Bedroom 1's bathroom · design review F-05 · accept the route (A) or a private bathroom (B)? · Taif / Palm House · A ADOPTED · B NOT ADOPTED: young children's room (owner, V9.0)

OPTION A ADOPTED by the owner (2 Nov 2026): no private bathroom; the wet areas stay grouped in the two clusters; night lights along the route. 2 Nov 2026, after the stair flip (option B, F-b) · bedroom 1 is the north-east room over the maid wing, 15.75 m² on axes, 13.9 m² clear, one room without a bath · nothing in the design files changes until the owner decides · all sizes assumed

bedroom 1 · A · 1 m = 0.95 cm · north up · brown dotted = the ground floor below

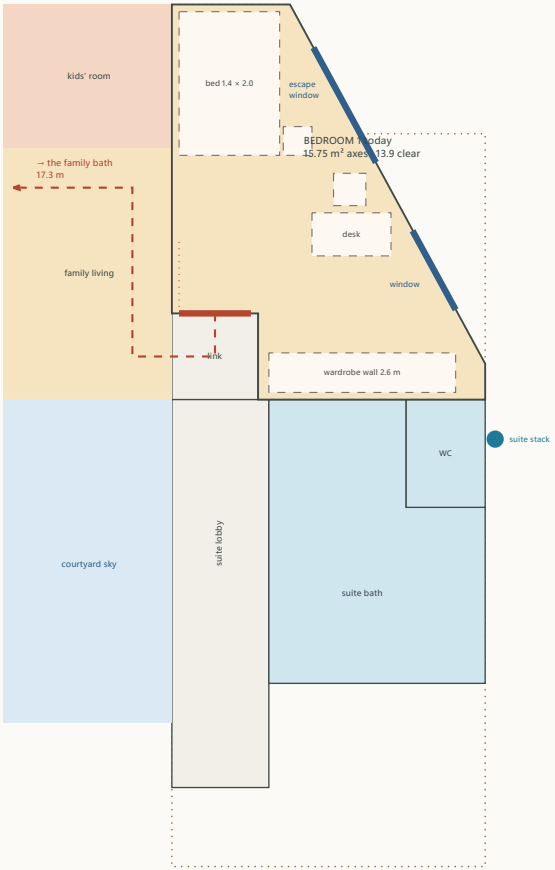
- **The walk, measured after Part 1** (the stair flipped, the family bath enlarged northwards; its door stays at x 4.25, y 9.3–10.3): bedroom 1's door → the family link → the family living, behind the sofa → the gallery's north part, past the stair arrival → the gallery → the bath's door: **17.3 m** (the same as before the flip: the bath grew, its door did not move). Five spaces, two of them lived in (the living, the gallery).

- **Who shares the family bath:** bedroom 1 (17.3 m), bedroom 2 (2.7 m), the kids' room and the family living (a bedroom later); bedroom 3 and the suite have their own. Since F-b it has **two compartments** (a WC by the shaft and the shower + double basin), so two children at once.

- **Comfort:** a child or a guest in bedroom 1 crosses the **family living** at night and in the morning, in sight of whoever is there; 17 m is the longest bathroom walk in the house (the suite's is 0, bedroom 3's 2.7, bedroom 2's 2.7).

bedroom 1 · B2 · 1 m = 0.95 cm · north up · brown dotted = the ground floor below

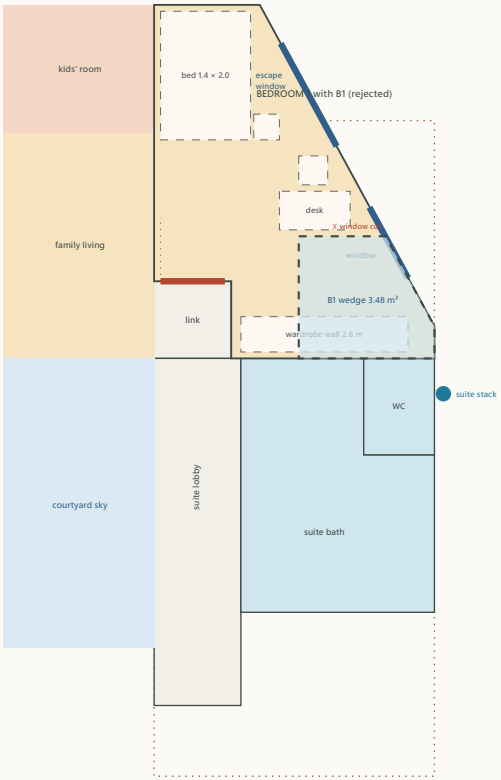
- **B2 (the best, drawn):** a bath along bedroom 1's **south wall**, x 10.6–13.311, y 5.0–6.5, its east end following the cut wall: **3.79 m² on axes, 2.49 × 1.3 clear less the slant ≈ 3.0 m²**: a walk-in shower 0.9 × 1.2 at the east end (its corner 0.02 m west of the cut wall), the WC in the middle facing north, the basin on the west wall, a **sliding 1.0 m door** from the room (no swing), a **small window on the cut wall** (y 5.35–5.85, sill +1.60, obscured). It is **next to the master suite's wet stack**: the pipes run 2.5 m east in the bath's own floor zone to the suite's stack outside the east wall (y 7.05), **over the GF maid room only** (the kitchen and its hood zone start at y 7.0; nothing over the master bedroom).

- **Bedroom 1 with B2: 11.96 m² on axes, ≈ 10.3 m² clear** (was 15.75 / 13.9): the bed 1.4 × 2.0 stays on the west wall with its bedside table, the desk and chair under the escape window, the wardrobe wall (2.6 m) becomes **two wardrobes, 1.3 m on the bath's wall and 0.9 m on the west wall** (2.2 m in all); the door's swing stays clear; the **escape window stays the room's** (the fire study unchanged); the second window (y 4.15–5.25) lights the desk. Still a full bedroom (a 1.4 bed, a desk, 2.2 m of wardrobe), no longer a two-bed room.

- **Drain:** the shower, the WC and the basin to one branch running east along the bath's south side to the **suite's stack** outside the east wall (y 7.05), 2.5 m; the branch crosses the room's south wall line at x 13.311 and turns south outside the wall for 0.6 m (or a second stack beside the suite's; the MEP engineer). **Over the GF maid room only**: not over the kitchen (y ≥ 7.0), its hood zone (the east wall y 10.2–11.2) or the master bedroom (x 8.95–13.311, y 11.9–19.25).

- **Structure (`studies/structure.typ`):** the maid wing's first-floor bay is a **solid 0.20 slab** spanning east–west 4.36 m to the cut wall; a 0.15 depressed zone cannot be cut from 0.20. Two ways, the engineer's choice: **(i)** cast the bay 0.35 thick under the bath with its top depressed 0.15 (as the suite bath, X10), or **(ii)** keep the slab and run the pipes **below** it in the maid room's ceiling void (the maid room gets a gypsum ceiling anyway; 3.1 m clear left) with a wall-hung WC and a shower tray raised ≈ 0.10. The bath's walls are light partitions on the slab (no beam; B6 at y 6.5 is the room's south wall beam, untouched).

- **Windows:** the bath's small window on the cut wall faces the lane side (obscured glass, a vent); the room keeps both its windows. **Ventilation:** the window plus an extract fan to the roof riser is not available here: an extract through the cut wall (a small louvre) or a duct in the ceiling void to the east wall.

- **Neighbours:** the maid room below hears the bath (pipes in a ceiling void: wrap them); the suite's WC closet shares the stack; the family link and the suite lobby are untouched; the family bath keeps serving bedroom 2, the kids' room and the living.

Recommendation: B2, if bedroom 1 is to be a guest room or an older child's room; otherwise A

- The route is the longest in the house and crosses the living: that is the real cost of A, and the only one. B2 answers it for ≈ 3 m² of the room and one more wet room; it is the only tidy position (B1 is a wedge that cuts a window, B3 takes the escape window). **Conditions for B2:** the engineer chooses the slab detail (i) or (ii); the MEP engineer the stack connection and the vent; the wardrobe split accepted.
- **If A:** keep the family bath as F-b (two compartments) and note in the house rules that bedroom 1's user has the family bath; nothing else to do.

bedroom 1 · B1 · 1 m = 0.95 cm · north up · brown dotted = the ground floor below

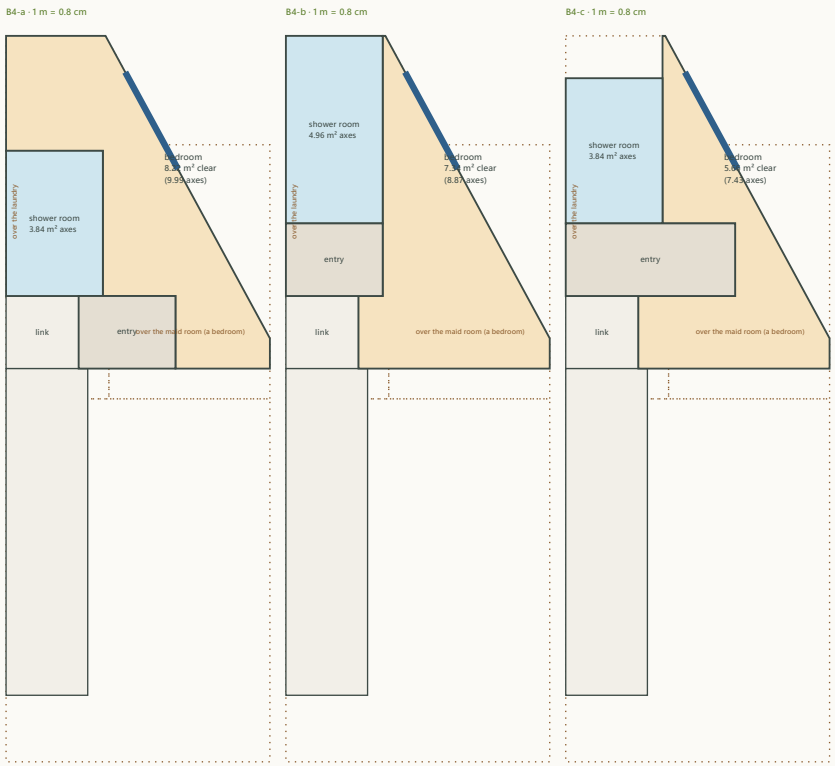
- **B1 (the south-east wedge, dashed on page 2):** x 11.2–13.311 on the cut wall, 3.48 m²: a wedge, its north wall cuts the second window (y 4.15–5.25) and leaves 0.8 m of the wardrobe wall: worse than B2 for the same plumbing. **B3 (the north-east corner):** the north-east corner (x 10.6–12.0, y 1.0–2.9) holds the room's **escape window** and the bed's head wall: a bath there moves the escape window and the bed; rejected without drawing.
